RE: Conditional Approval of GE's February 16, 1999 Submittal Titled *Conceptual Barrier Design for Lyman Street Site*

GENERAL ELECTRIC COMPANY
 PITTSFIELD, MASSACHUSETTS
LYMAN STREET PARKING LOT
SOURCE CONTROL INVESTIGATION
PROPOSED CONTAINMENT
BARRIER AND SUPPLEMENTAL
SAMPLING LOCATIONS

FIGURE
7

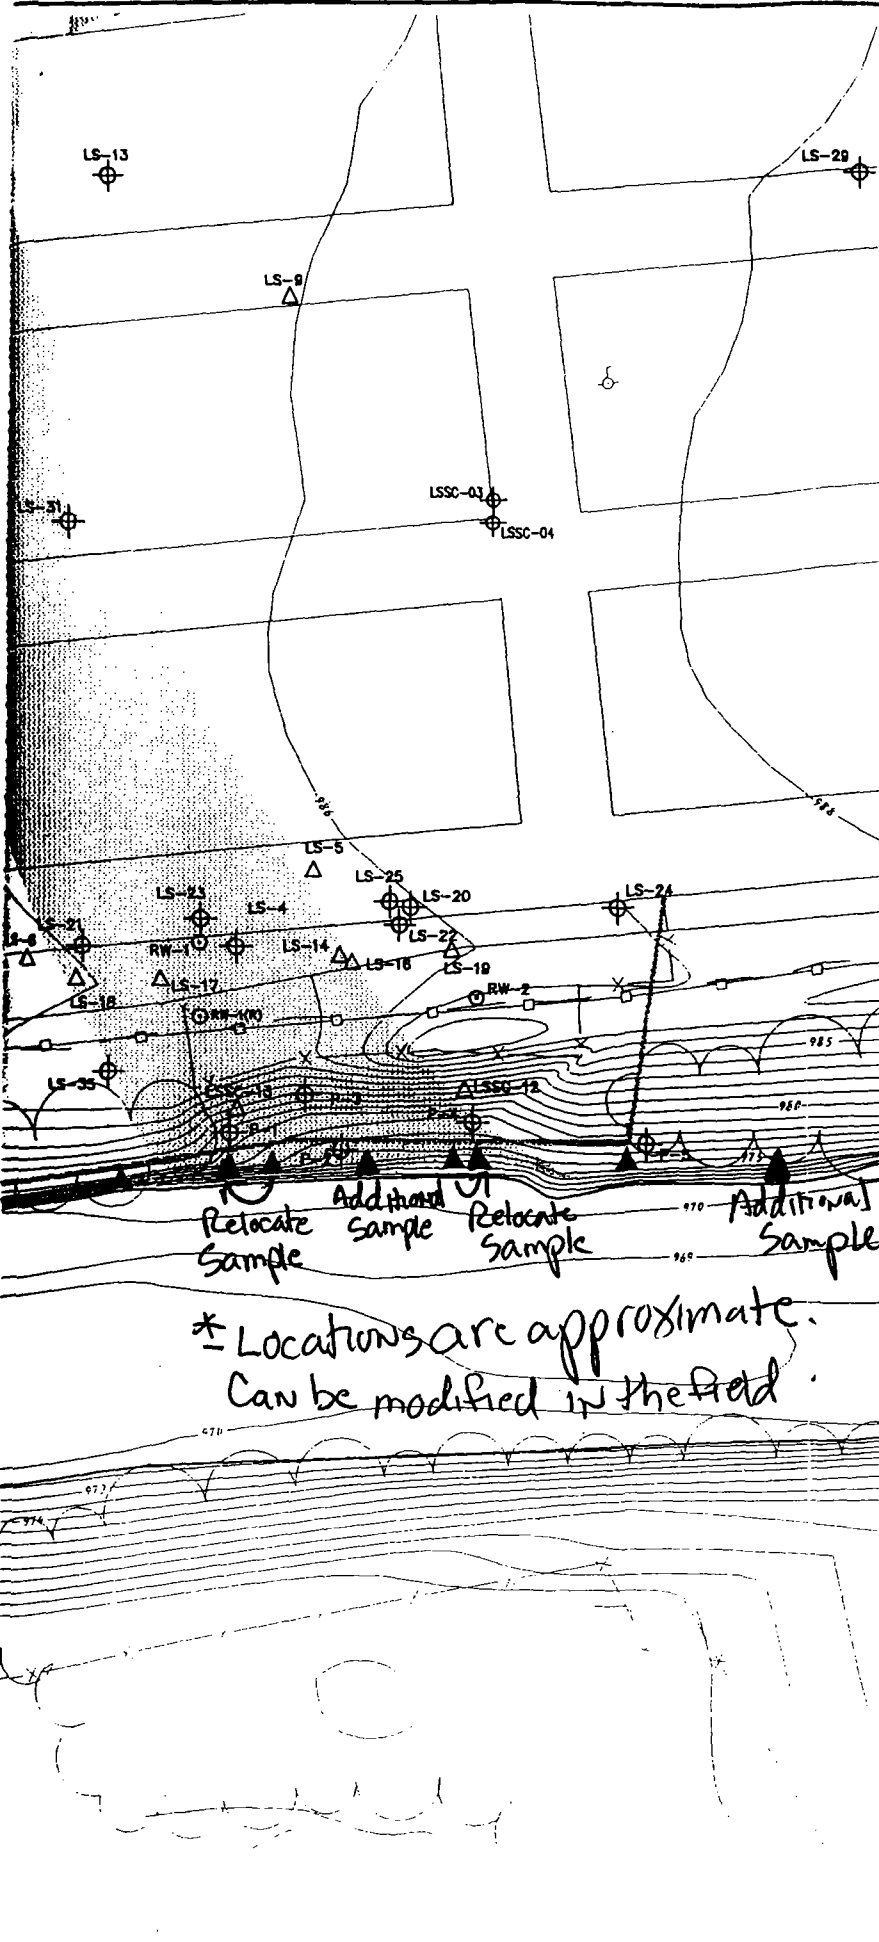
8. GE shall add two additional sample locations, one between P-2 and P-4 and one approximately 30 feet east of P-5. Also, GE shall relocate two of the samples as shown on a revised Figure 7 (see attached).
